From: Tom McCormick <tommccormick@mac.com>
Sent: Thursday, February 25, 2016 10:15 AM
To: Countryman, Ryan
Cc: Gretchen Brunner; Richard Schipanski; Mike Swenson, PE, PTOE; Kurt Gahnberg; Tom Mailhot; Debbie Tarry
Subject: Impact of 2045 buildout date on Traffic Assumptions and Ordinary High Water Mark at Point Wells

II. Impact of 2045 buildout date on the Ordinary High Water Mark

SITE ANALYSIS: SETBACKS

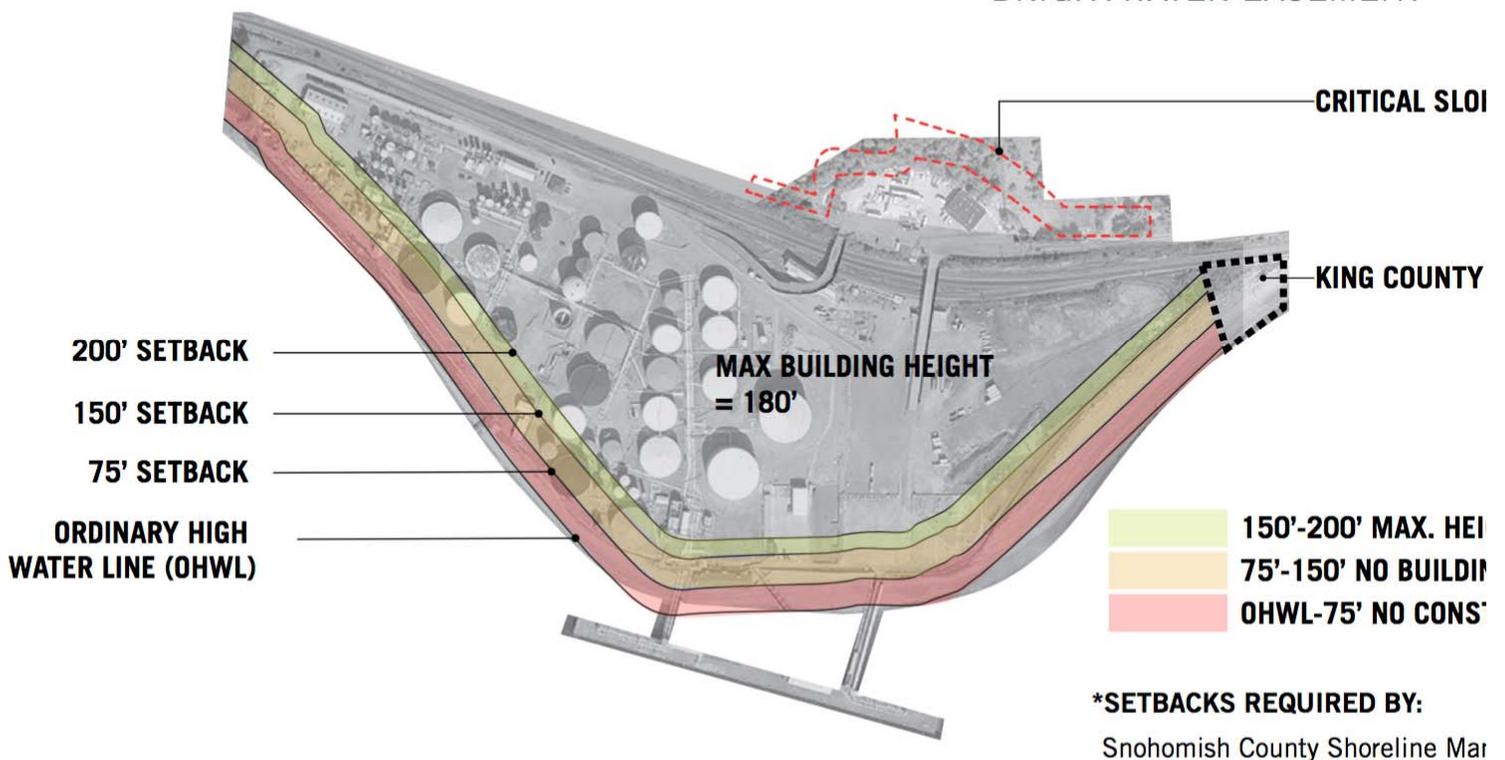
The above definition of "Ordinary High Water Mark" contemplates a changing environment ("as it may naturally change thereafter"). As such, we request that the DEIS address how the setbacks, open space, and other development requirements and restrictions will be affected under several scenarios that contemplate a changing environment—for example, a 6-inch increase of the Ordinary High Water Mark by 2045, a 12-inch increase, an 18-inch increase, a 24-

inch increase, etc. Additionally, we request that the DEIS address the impact of additional increases of the Ordinary High Water Mark expected to occur from 2045 through 2100 and beyond.

We expect that the hearing examiner will consider the Ordinary High Water Mark not as it exists as of the date of the hearing, but rather as it is expected to "naturally change thereafter" at full buildout (2045) and continuing through through 2100 and beyond. The hearing examiner will undoubtedly look to the DEIS to inform him/her about the Ordinary High Water Mark as it is expected to change over time. As noted above, a change in the Ordinary High Water Mark will have a significant impact on the setbacks, open space, and other development requirements and restrictions.

We request that the DEIS include a thorough analysis of the Ordinary High Water Mark as it is expected to change over time (with worst case scenarios), and an analysis of impacts of the changing Ordinary High Water Mark on the setbacks, open space, and other development requirements and restrictions.
